Access Compliance Report

Public Rights-of-Way

(Curb Ramps)

Intersection ID: 21411	Main Street: MONROE_RD	Cross Street: SARDIS_RD_NORTH	Location: NE
ADA ID: D7336FC3DD0C	Ramp Type: BlendTrans2	Initial Pass/Fail: Pass	Overall Compliance: No
Severity Score: 2.5			
Codes/Mitigation Info/Possible Solution		Field Measurements/Component Compliance

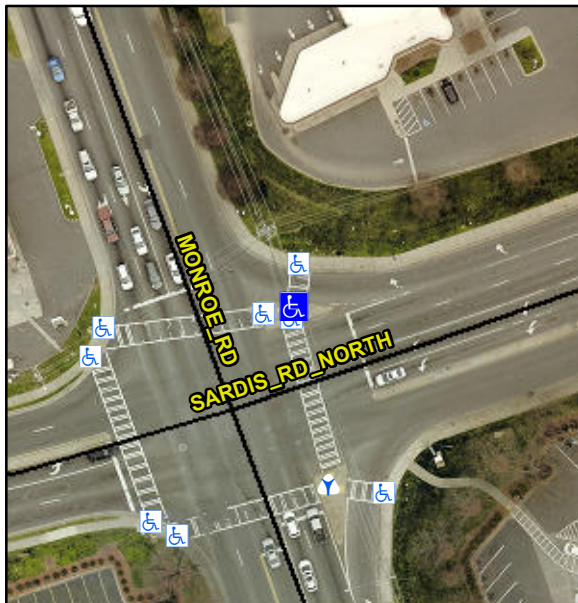
Surveyor Notes:

LOCATED ON MEDIAN

PROW/ADA:

Not Found, R305.1.4, R305.2

Possible Solutions:

Remove & Replace Curb Ramp With Two New Directional Ramps or Equivalent.
